SUNDRY NOTICES AND REPORTS ON WELLS

OXY USA WTP Limited Partnership

8. Well Name and No.
#86

9. API Well No.
30-025-10954

OXY USA WTP LP
Myers Langlie Mattix Unit #86
API No. 30-025-10954

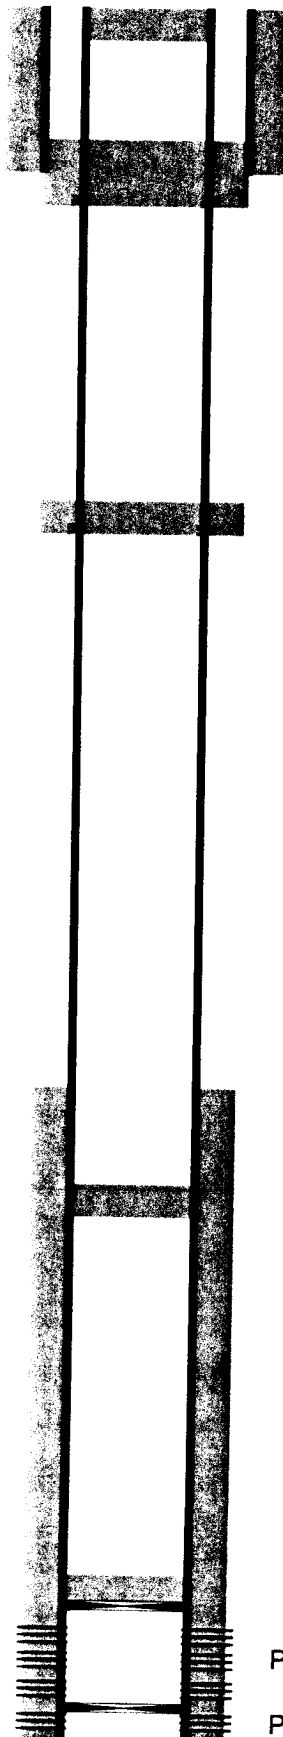
1. Approval is granted to plug this well with the following modifications to the proposed procedure:
2. All plugs below the surface plug should be tagged for casing shoes and the top and base of the salt.
3. The 5.5 inch to 8.625 inch casing annulus must be cemented to the surface.

*****All plugs below the surface plug must be at least 100' and 25 sacks of cement.**
